City of Sandy

Planning Commission Meeting

Meeting Date: Monday, August 26, 2019

18-030 DR/VAR/CUP Funtime RV | 25 - 187 |

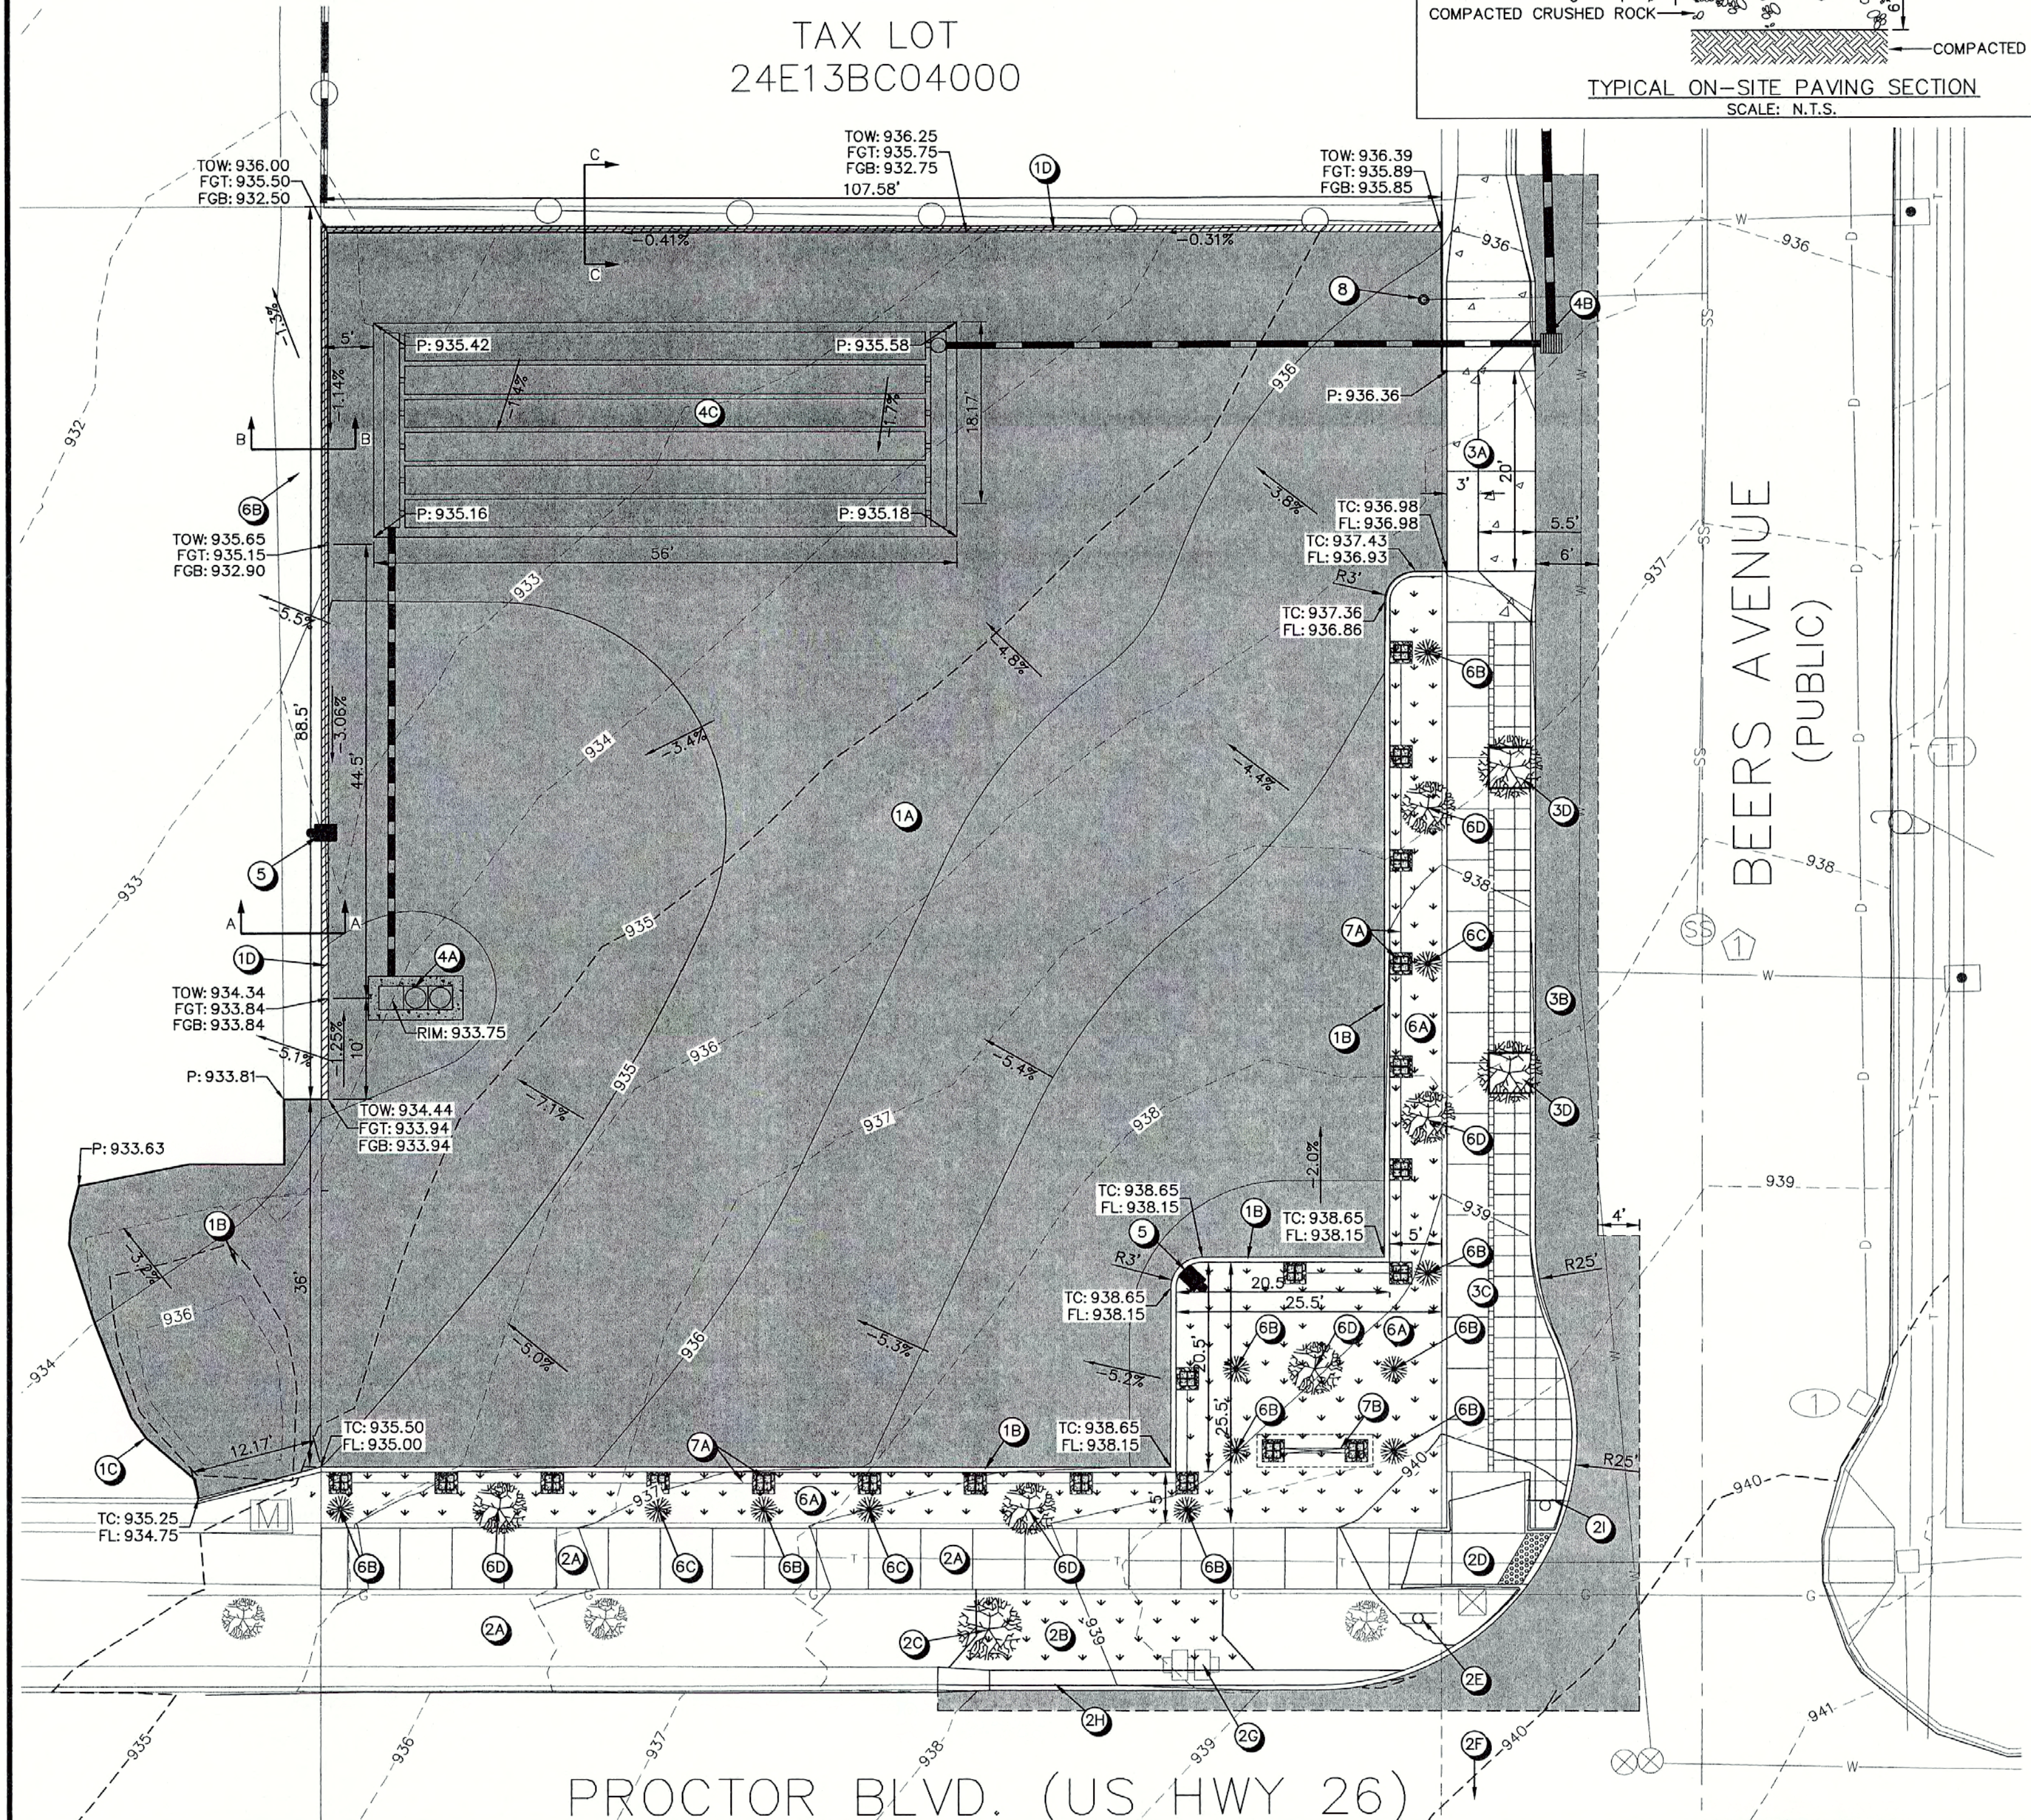
RESPONSE: *The applicant has submitted an **updated** Landscaping Plan (**Exhibit N, Sheet C3**) (~~Exhibit D, Sheets C3 & C5~~) with associated key notes detailing the proposed landscaping. The proposal includes incorporating a 5-foot wide planter strip along the east and south property lines/frontages with a 25.5-foot by 25.5-foot planter area located in the subject property's southwest corner. Item 4 above states that where a curb or the edge of a landscaped area is used as a wheel stop for parking, the planter or boundary plantings shall be a minimum width of 7.5-feet. **While the proposed paved area is not a parking lot by definition, but rather is considered an outdoor display area, the intention is to store recreational vehicles on site; therefore, it is recommended that the applicant redesign the landscape strips to be a minimum of 7.5-feet wide or include a wheel stop to protect the landscaping.** The proposal is to display (i.e. park/store) RVs upon the property and the intention of this criteria is to protect landscape buffers while creating a barrier between parked vehicles and pedestrians, therefore it is reasonable to conclude that either a wheel stop, or increased planter depth of 7.5-feet is required. While the proposal does not include either of these elements it does propose incorporating an ornamental fence to enhance the "village" scale and provide the separation that this section of the code intends to achieve. Staff supports the alternative to incorporate the ornamental fence as opposed to wheel stops and/or an increased planter depth. Should landscaping be damaged by RVs it will need to be replaced.*

RESPONSE: *The Landscape Plan (Exhibit N, Sheet C3) includes the installation of an ornamental fence. The proposed fence includes square column wraps at approximately 2-feet wide, standing 4-foot tall not including a 3-inch thick beveled concrete column cap. The proposed columns are to be wrapped with a stone veneer in Bucks County color which is consistent with the desired Sandy Style masonry standards for new development within the C-1 zone district. Between the columns the proposal includes installing two, horizontal trex rails (2-inch by 6-inch) to complete an ornamental fence bordering the subject property. The proposed rails are proposed to be brown which is also in keeping with the Sandy Style. **Should the proposed fencing be approved the applicant shall submit the proposed trex rail color for staff's final approval. The proposed color shall be compatible with Appendix C, Building Color Palette or be of a natural stain/finish. Once approved the applicant shall update the plans to reflect the choice.** ~~The proposal includes installing a 3 foot tall chain link fence dividing the proposed pavement and landscaped area parallel to the west property line. Per Item B above a chain link fence is only permitted when a landscape buffer is provided in accordance with Chapter 17.92 which staff has concluded has not been met. The applicant shall resubmit a landscape plan that provides a combination of trees, shrubs, or evergreen ground cover for at least 75 percent of the required landscaping area for staff review and approval.~~*

RESPONSE: *Per Exhibit N, Sheet C3 ~~Exhibit D, Sheet C3~~ the proposal will incorporate new asphalt paving surface to be used for the outdoor product display or storage of merchandise which is proposed for the subject site.*
